**Comments in Reply to
PGE August 10, 2010 Reply Comments
Public Utility Commission of Oregon
Docket No. LC 48**

September 1, 2010

**Public Utility Commission of Oregon
Docket No. LC 48
Comments in Reply to PGE Reply Comments**

Figure R1: NPVRR of Early Retirement and Boardman through 2040 Portfolios with PGE Reference Case Gas Prices

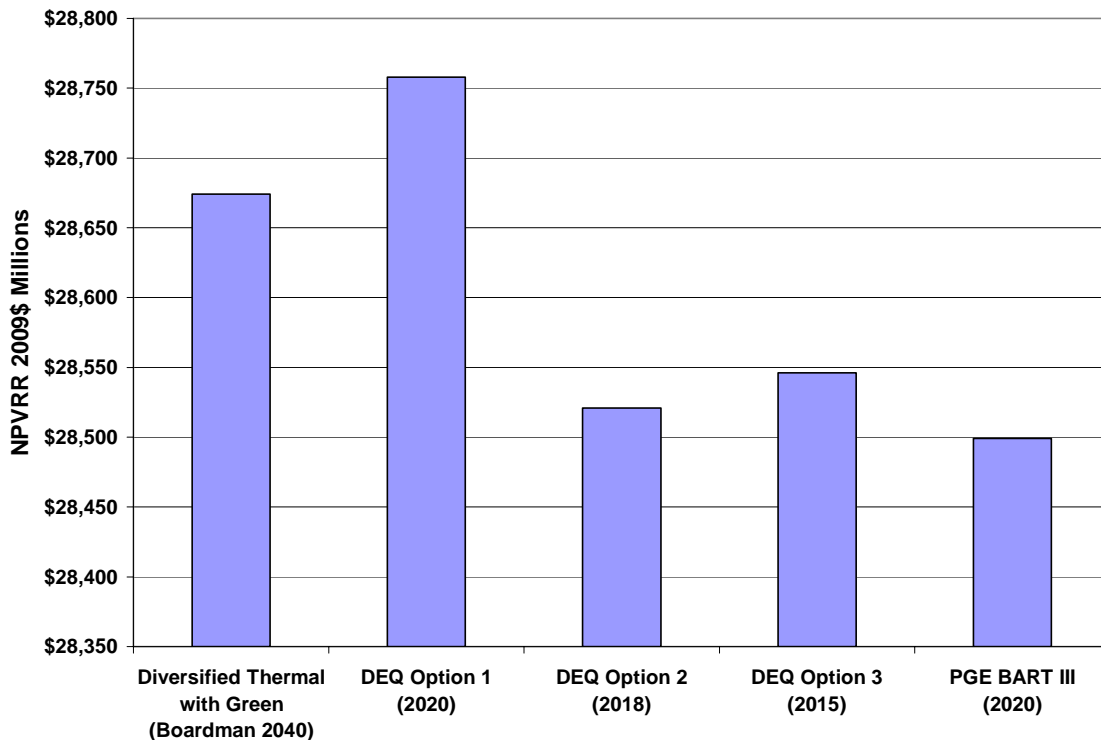
The results of PGE’s new modeling analyses of the DEQ Options and its BART III Proposal confirm this conclusion. Figure R1, below, shows that even assuming PGE’s reference case natural gas prices, DEQ Options 2 and 3 (which feature retirement of Boardman in 2018 and 2015) are lower cost alternatives than continuing to operate the plant through 2040. Retiring Boardman at the end of 2020, as in PGE’s BART III Proposal, also would be a lower cost option than operating the plant through 2040.

Figure R2: NPVRR of Early Retirement and Boardman through 2040 Portfolios with PGE Low Case Gas Prices

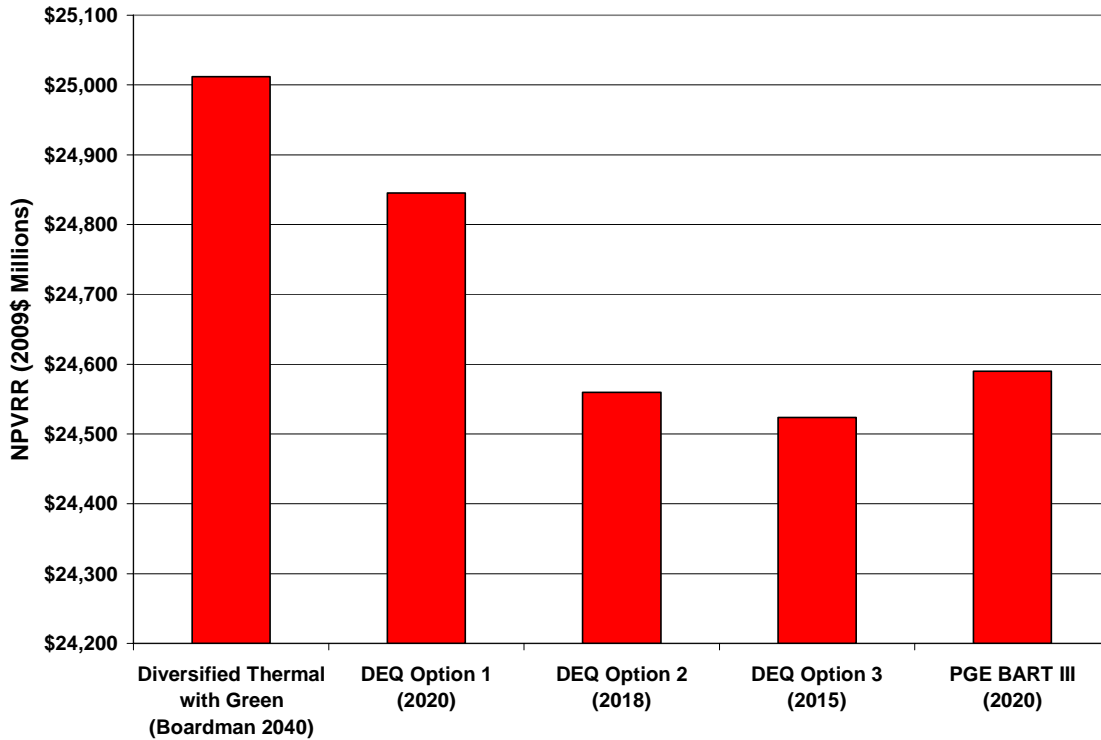
Figure R2, below, then presents the same comparison but reflects PGE’s low IRP gas prices. These low gas prices are more comparable to the base or reference gas price forecasted by the NWPCC, the Oregon PUC Staff and others than PGE’s reference of high gas prices.

Consequently, the results of PGE’s own modeling analyses show that retirement of the Boardman plant in 2015 or 2018 would be a lower cost option even with the biased assumptions discussed in the STC May Comments and in these Reply Comments. Indeed, when less biased, and more reasonable, natural gas prices are used, continuing to operate the Boardman plant through 2040 (that is, the Diversified Thermal with Green portfolio) is seen to be significantly more expensive than the early retirement options.

Figure R3a: NPVRR Difference between PGE Diversified Thermal with Green (2040) and DEQ Option 2 (2018) Portfolio (2009\$ Millions)

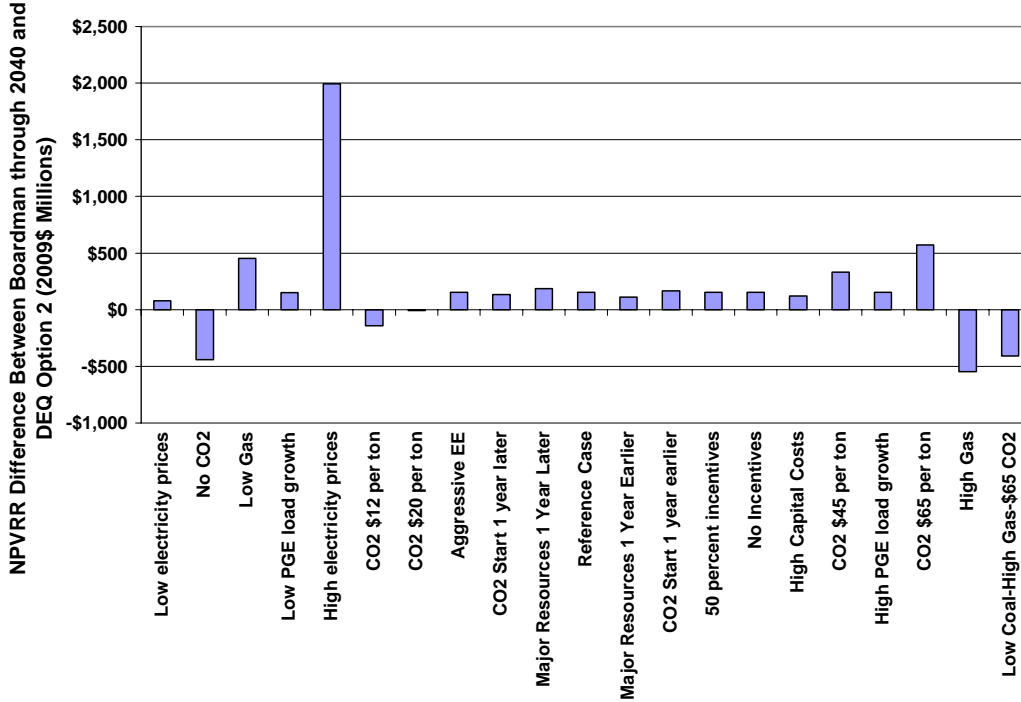
Figures R3a, R3b, and R3c, below, show the NPVRR differences between the Company’s Diversified Thermal with Green portfolio (Boardman through 2040) and the new DEQ Option 2 (2018), DEQ Option 3 (2015) and BART III (2020) early retirement portfolios. As can be seen, in each figure, operating Boardman through 2040 is the more expensive option in at least 16 of 21 scenarios modeled by PGE. An upward facing bar in these Figures means that operating Boardman through 2040 would be the more expensive alternative.

Figure R3c: NPVRR Difference between PGE Diversified Thermal with Green (2040) and PGE BART III (2020) Portfolio (2009\$ Millions)

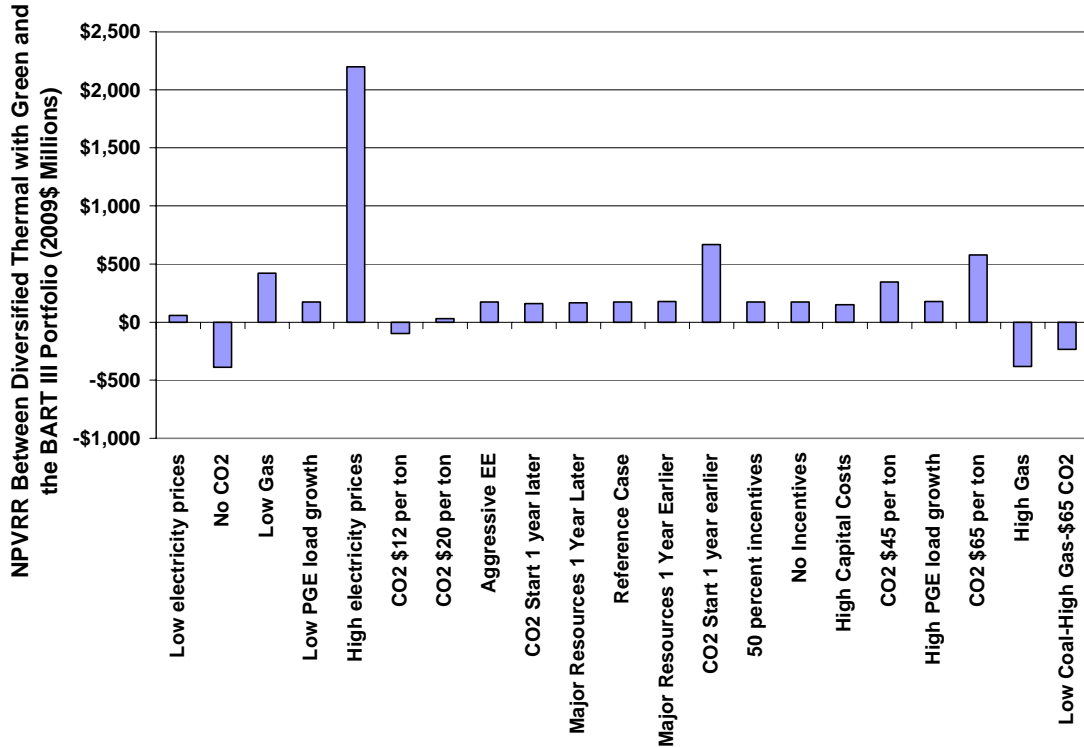
It is important to recognize that the few scenarios in which operating Boardman through 2040 is the lower cost option include the two scenarios with completely unrealistic high gas prices and the three scenarios with no CO₂ prices or low CO₂ prices. Consequently, in order to accept that operating Boardman through 2040 is a lower cost option than retiring the plant in 2015, 2018 or even 2020, it is necessary to accept either that gas prices will be dramatically higher than anyone (including PGE and PIRA) now projects and/or that there will be no federal regulation of greenhouse gases at any time between 2010 and 2040 or that federal regulation will lead only to low CO₂ prices.

Figure R5. Natural Gas Prices for the Years 2010 through 2025 Used in PGE IRP Modeling Analyses vs. NWPCC, Oregon PUC Staff, AEO 2010 and NYMEX Futures (Levelized in 2009\$)

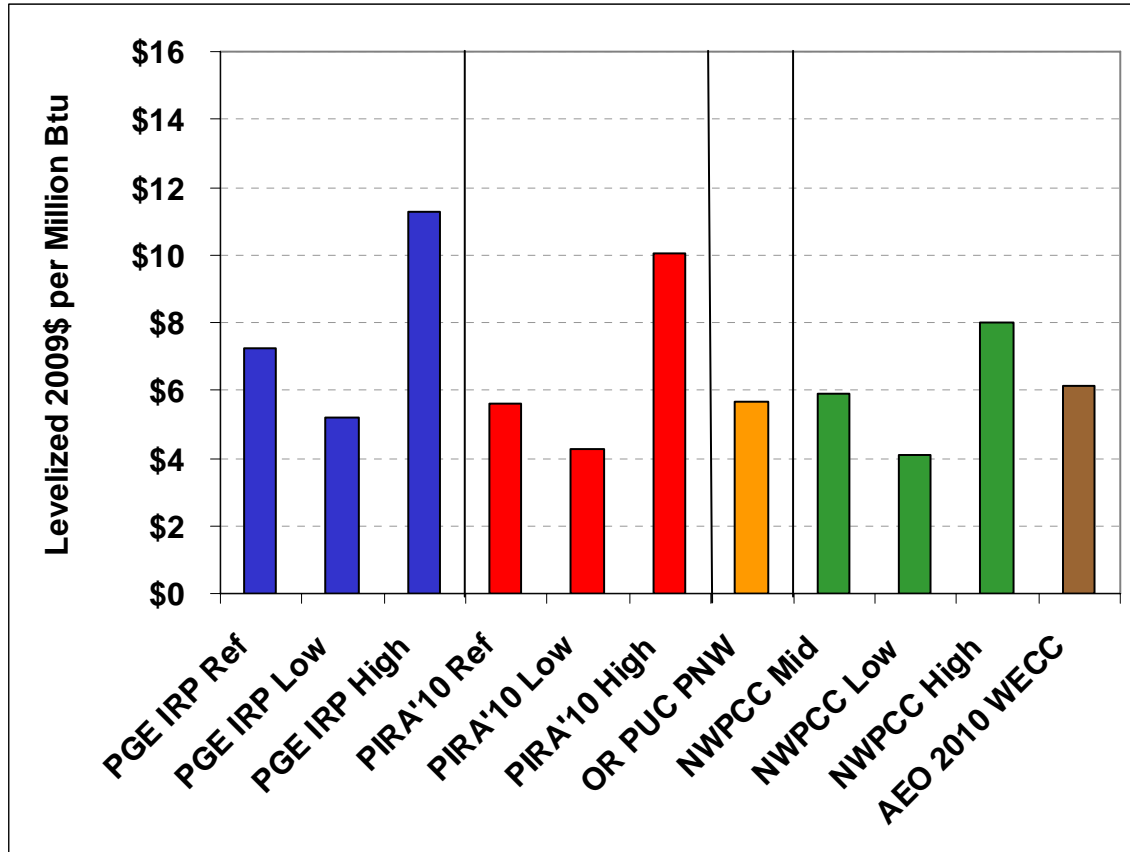
Figures R4 Confidential and R5, below, compare the gas prices that PGE uses in its new DEQ Option and BART III portfolio analyses with the same gas price forecasts that were presented in Figures 1 through 5 of the STC May Comments. The gas prices in these new Figures are presented on precisely the same basis as the gas prices are discussed in the April 2010 IRP Addendum, that is, for the years 2010 through 2025.⁵ For example, the gas prices in Figures R4 Confidential and R5 represent the same average of the Sumas and AECO Hub prices as PGE presented in Figure 5-1 of its 2009 IRP. The PIRA 2010, Oregon PUC staff, NWPCC and AEO 2010 gas price forecasts also are for the northwest.

- The reference case natural gas prices that PGE used in its new IRP modeling analyses are significantly higher than the recent reference case gas prices forecasted by the Oregon PUC Staff, the NWPCC and the EIA's AEO 2010.
- The reference case natural gas prices that PGE used in its new IRP modeling analyses are significantly higher than PIRA's 2010 projected reference case gas prices.
- The reference case natural gas prices that PGE used in its new IRP modeling analyses are significantly higher than NYMEX futures prices.
- The year-to-year gas price shape in Figure R4 Confidential appears to be the same as that reported in IRP Figure 5-1 on page 77 of PGE IRP. The levelized costs for the PGE IRP gas prices presented in Figure R5 are precisely the same as PGE reported in its November 2009 IRP.

- The high gas prices that PGE used in its new IRP risk assessments are significantly higher than the NWPCC high gas prices and higher than the PIRA 2010 high gas prices, as well.

Figure R8: PGE IRP vs. PIRA and NWPCC Gas Price Forecasts

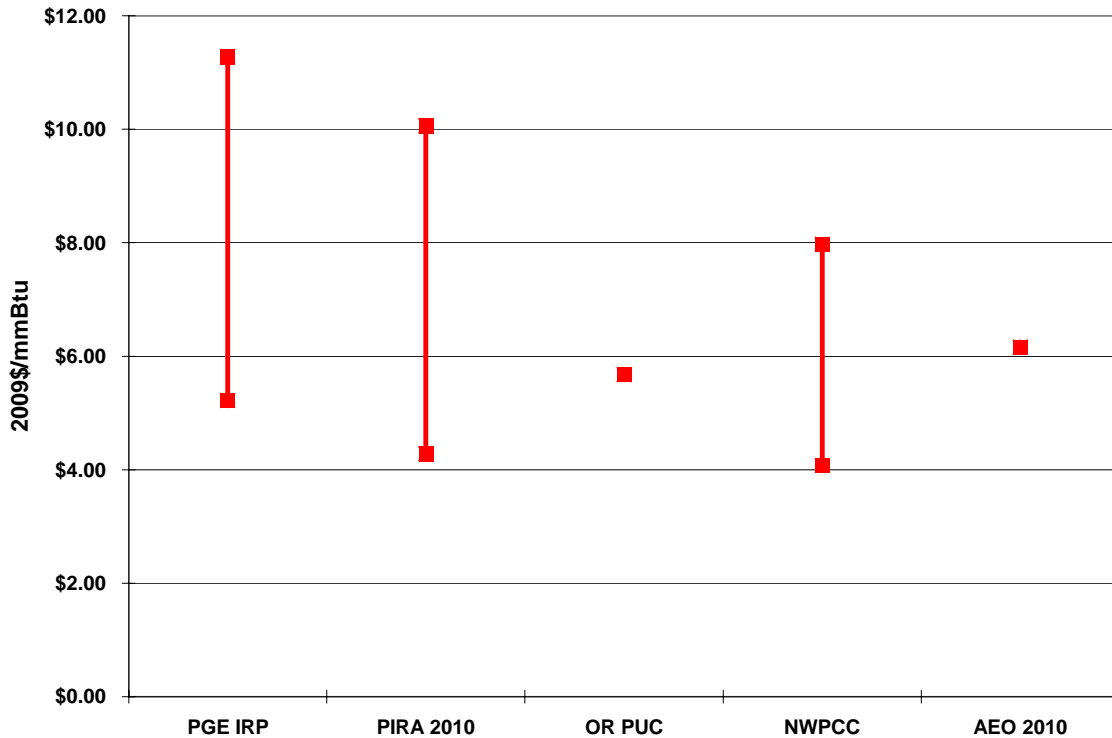
Figure R8, below, compares, on a levelized basis, the range of gas prices that PGE uses in its IRP analyses with the current NWPCC and PIRA 2010 gas prices. As can be seen, the range of gas prices that PGE uses in its IRP analyses is significantly higher than the PIRA 2010 and NWPCC gas price ranges. Figure R8 also shows that the Oregon PUC Staff gas price forecast is only slightly above the low end of the range of gas prices that PGE continues to use in its new IRP analyses.

Figure R9: Boardman Capacity Factors 2010-2040 in Diversified Thermal with Green Portfolio – all CO₂ Price Scenarios

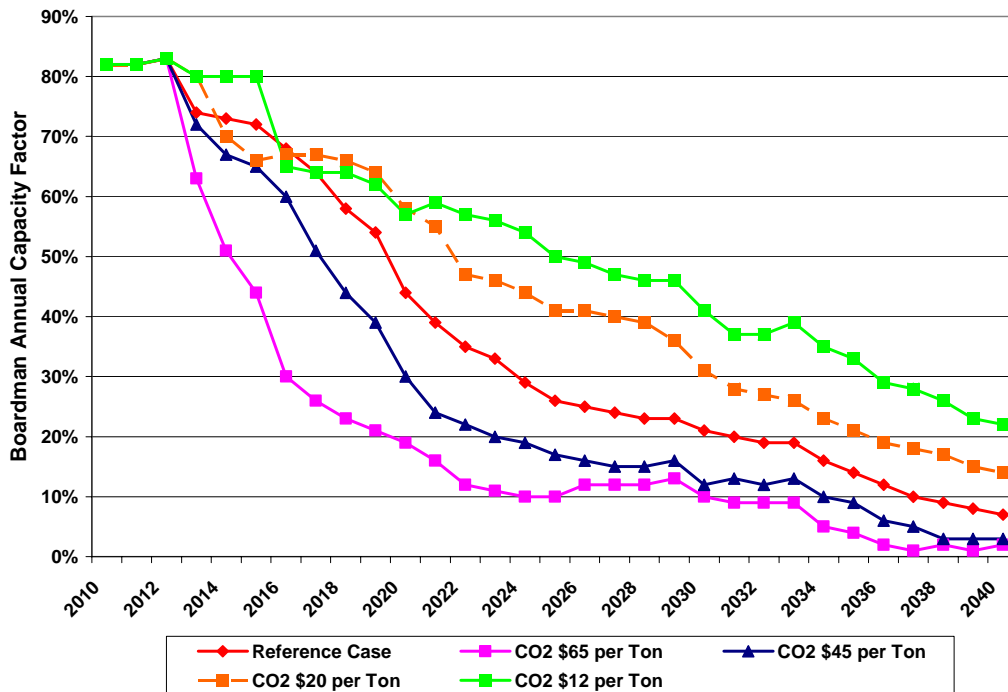
In fact, as shown in Figure R9, below, in the \$20 CO₂ scenario, Boardman would be operating at only a 47 percent capacity factor as early as 2022, with its capacity factor declining from that point. In the \$12 CO₂ scenario, the plant would operate at only a 50 percent capacity factor as early as 2025, declining from that point. The \$0 CO₂ scenario is not shown in Figure R9 because we do not believe it is credible to argue that there will be no regulation of greenhouse gases at any time between 2010 and 2040.

year.”²⁰ However, that would mean that, in all credible CO₂ scenarios, by 2025, at the latest, Boardman will be an intermediate, not a base load facility. Moreover, PGE’s claim ignores that fact that the Boardman plant was offline during the peak summer months of 2009. Thus, the plant cannot be counted on to “provide valuable seasonable supply during the highest load months” as PGE claims.

The projected steady decline in performance in all credible CO₂ price scenarios raises serious questions about the prudence of investing \$510 million for environmental upgrades on a coal-fired unit that would no longer be operating as a baseload unit.
